DRAFT CREVE COEUR CREEK TMDL  
PUBLIC COMMENTS

Public Notice  
June 22 – Aug. 6, 2012

**Creve Coeur Creek  
WBID # 1703**

**FIGURE 4.** Comparison of median illness risk for adults when total ENT concentration (at 35 cfu 100 mL<sup>-1</sup>) is attributed to a mixture of primary POTW effluent (sewage) and seagull feces (gulls).

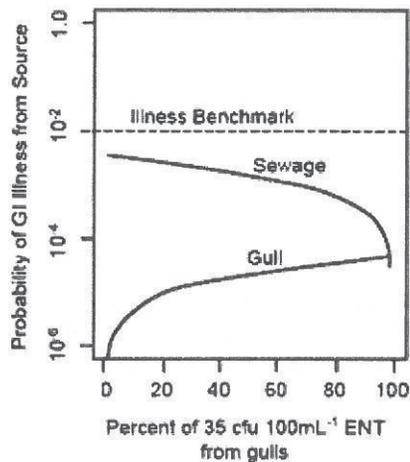
**b. The TMDL target should consider the effects of bacteria source on human health risk.**

Recent QMRAs by USEPA contractors have shown that setting appropriate recreational indicator bacteria limits (i.e., corresponding to illness rates of 8-9 per 1,000 WBCR exposures) requires an understanding of bacteria sources (Schoen and Ashbolt 2010, Soller et al. 2010). As shown in Figure 4 from Schoen and Ashbolt (2010), when percent of bacteria from non-human sources (in this case gulls, as shown on the x-axis) is above roughly 80%, the cumulative illness risk (or the sum of the gull and human/sewage risk curves) is roughly half the USEPA's tolerable illness rate (as indicated by the "illness benchmark" horizontal line). Stated another way, when the percent of bacteria indicators from human fecal sources is low, default recreational criteria are overprotective and can be safely increased. Further supporting this understanding, as shown in Figure 3b from Soller et al.(2010), predicted illness risks associated with recreational contact with a variety of fecal sources all at uniform concentrations of 126 col/100ml *E. coli* indicate that illness rates (and therefore appropriate recreational limits) are very much a function of bacteria source. While some source tracking information is available within the USGS study, a phased TMDL approach would allow the collection of additional source data, which is essential given the very rough nature of the USGS source tracking methods.

- b. The load duration curve must be adjusted so that sample data and TMDL target have comparable averaging periods.**

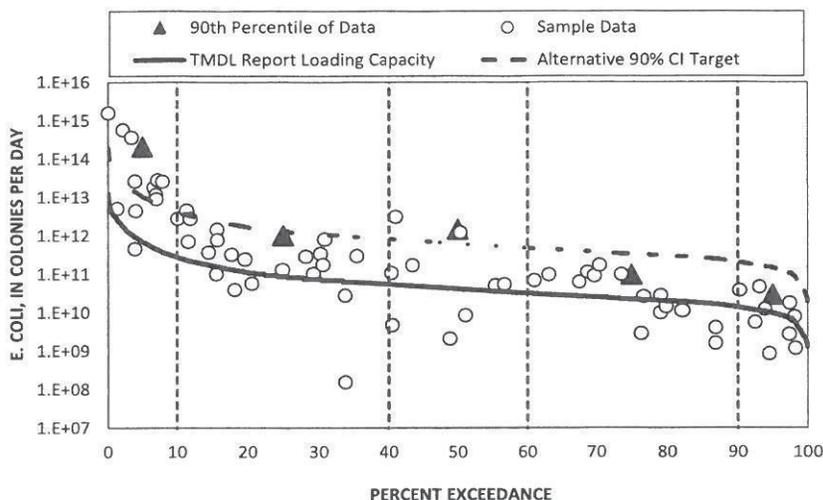
As discussed above, technical guidance developed by the USEPA (2007c) suggests that load duration curves should be calculated from data and criteria that have the same averaging period. Data used in the TMDL report did not have the same averaging period. In the TMDL, the Department multiplied the recreational season geometric mean criterion by a daily flow value to obtain the loading capacity for Creve Coeur Creek. This loading capacity was then compared to daily bacteria measurements and geometric means of data from various daily flow exceedance intervals.

The correct way to calculate the TMDL using a Load Duration Curve would be to either 1) convert the bacteria and flow data into recreational season geometric mean values and compare them to the geometric mean water quality criterion or 2) convert the recreational season water quality criterion to a daily value and compare it to the daily data. Either method would provide a more accurate representation of existing loading conditions relative to intended water quality criterion. The first method of converting the sample data to a recreational season geometric mean is complicated by the fact that limited data are available from most years to calculate a representative geometric mean value. However, the second method of converting the average water quality criterion into a daily value is a straightforward process. Appendix B of USEPA's (2007c) technical guidance includes an example bacteria calculation that converts a non-daily bacteria criterion to a daily value using statistical procedures outlined in USEPA (1986). This example is directly applicable to Creve Coeur Creek and is illustrated in the following paragraphs.

**Figure 11. Box Plots of BMP Study Geometric Means for Fecal Coliform by Selected BMP Category**

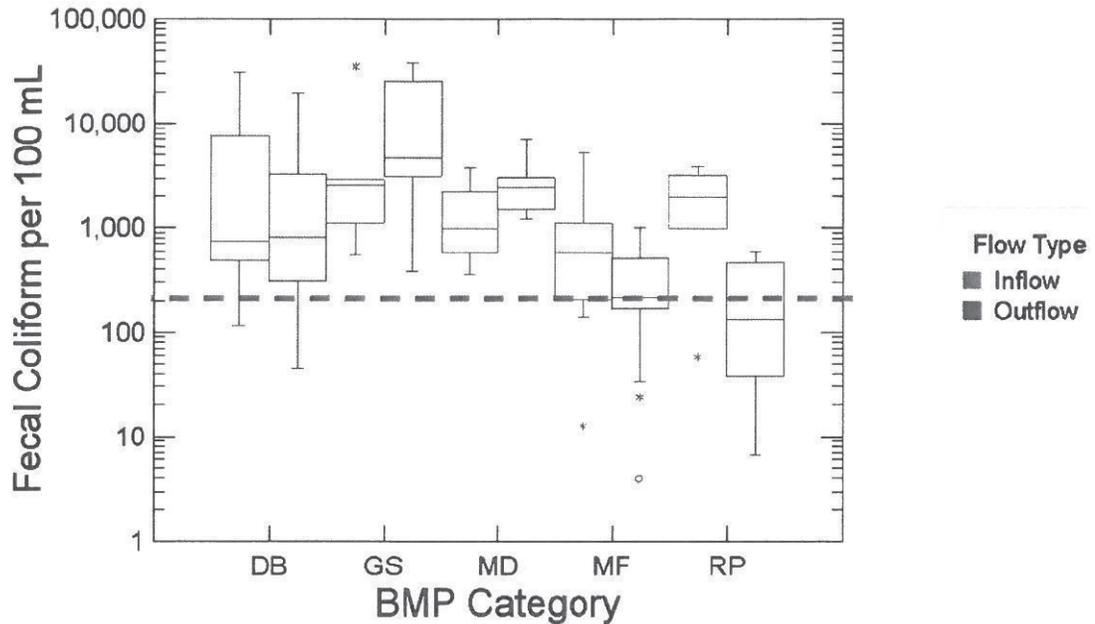
The District believes that technical feasibility must be considered when implementing any TMDL provisions into MS4 permits. Such a position is supported by the Maximum Extent Practicable (MEP) standard and minimum control measures approach embodied in the Clean Water Act. The reality of the MEP standard is supported by results generated by the International Stormwater Best Management Practice (BMP) Database (BMP DB). The BMP DB is a warehouse for performance data of various urban stormwater BMPs. Recently, data from the BMP DB were used to evaluate the performance of various structural BMPs in treating bacteria (see below for figure, with permission). Results from this analysis suggest that typical flow-through and passive control BMPs may not be capable of consistently achieving WBCR criteria, depending upon the expressed average period or duration. The ability of other BMPs, such as infiltration or capture/reuse systems, are constrained by soil infiltration conditions, available open space, land availability, reuse opportunities, and infrastructure or utility conflicts. The MEP standard must be employed in implementing MS4 controls, including the development and implementation of the Creve Coeur Creek TMDL.

**FIGURE 4.** Comparison of median illness risk for adults when total ENT concentration (at 35 cfu 100 mL<sup>-1</sup>) is attributed to a mixture of primary POTW effluent (sewage) and seagull feces (gulls).

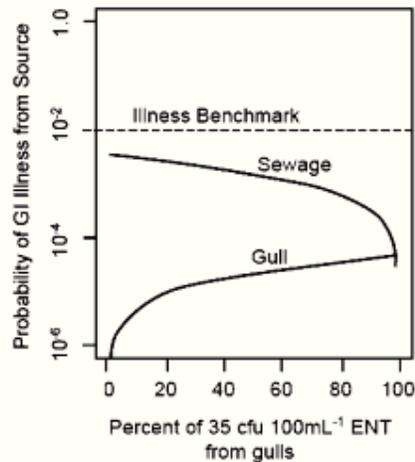
**b. The TMDL target should consider the effects of bacteria source on human health risk.**

Recent QMRAs by USEPA contractors have shown that setting appropriate recreational indicator bacteria limits (i.e., corresponding to illness rates of 8-9 per 1,000 WBCR exposures) requires an understanding of bacteria sources (Schoen and Ashbolt 2010, Soller et al. 2010). As shown in Figure 4 from Schoen and Ashbolt (2010), when percent of bacteria from non-human sources (in this case gulls, as shown on the x-axis) is above roughly 80%, the cumulative illness risk (or the sum of the gull and human/sewage risk curves) is roughly half the USEPA's tolerable illness rate (as indicated by the "illness benchmark" horizontal line). Stated another way, when the percent of bacteria indicators from human fecal sources is low, default recreational criteria are overprotective and can be safely increased. Further supporting this understanding, as shown in Figure 3b from Soller et al.(2010), predicted illness risks associated with recreational contact with a variety of fecal sources all at uniform concentrations of 126 col/100ml *E. coli* indicate that illness rates (and therefore appropriate recreational limits) are very much a function of bacteria source. While some source tracking information is available within the USGS study, a phased TMDL approach would allow the collection of additional source data, which is essential given the very rough nature of the USGS source tracking methods.

- b. The load duration curve must be adjusted so that sample data and TMDL target have comparable averaging periods.**

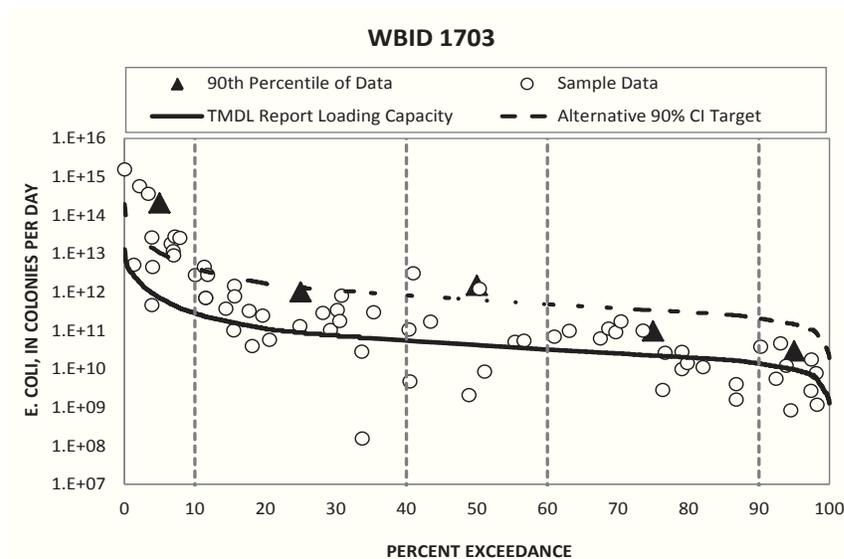
As discussed above, technical guidance developed by the USEPA (2007c) suggests that load duration curves should be calculated from data and criteria that have the same averaging period. Data used in the TMDL report did not have the same averaging period. In the TMDL, the Department multiplied the recreational season geometric mean criterion by a daily flow value to obtain the loading capacity for Creve Coeur Creek. This loading capacity was then compared to daily bacteria measurements and geometric means of data from various daily flow exceedance intervals.

The correct way to calculate the TMDL using a Load Duration Curve would be to either 1) convert the bacteria and flow data into recreational season geometric mean values and compare them to the geometric mean water quality criterion or 2) convert the recreational season water quality criterion to a daily value and compare it to the daily data. Either method would provide a more accurate representation of existing loading conditions relative to intended water quality criterion. The first method of converting the sample data to a recreational season geometric mean is complicated by the fact that limited data are available from most years to calculate a representative geometric mean value. However, the second method of converting the average water quality criterion into a daily value is a straightforward process. Appendix B of USEPA's (2007c) technical guidance includes an example bacteria calculation that converts a non-daily bacteria criterion to a daily value using statistical procedures outlined in USEPA (1986). This example is directly applicable to Creve Coeur Creek and is illustrated in the following paragraphs.

**Figure 11. Box Plots of BMP Study Geometric Means for Fecal Coliform by Selected BMP Category**

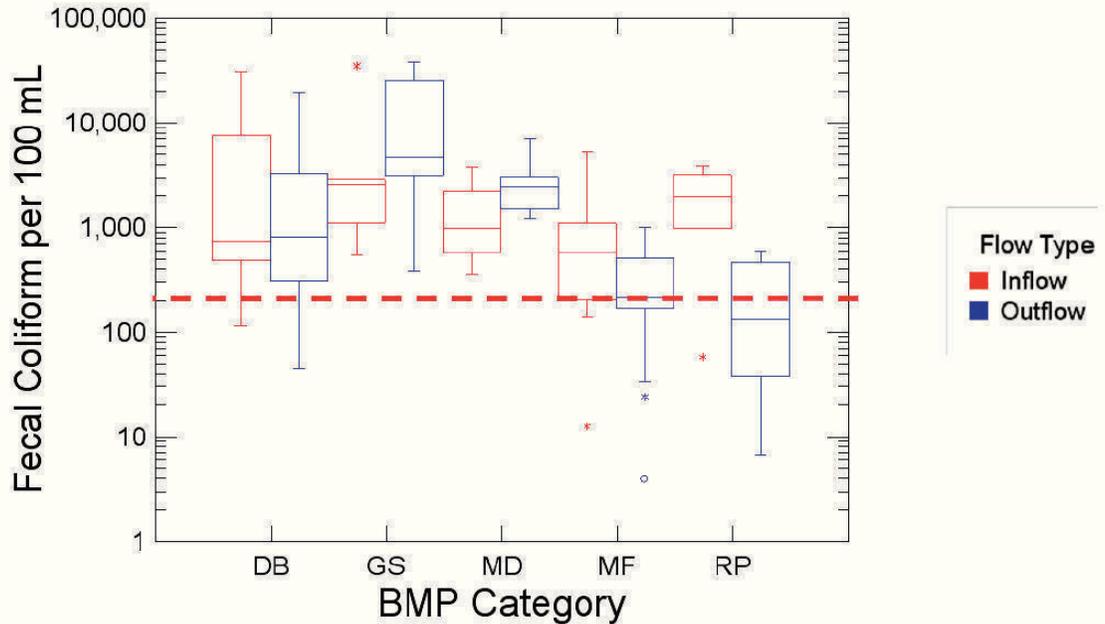
Please note that the entire BMP DB report on Fecal Indicator Bacteria can be found at:
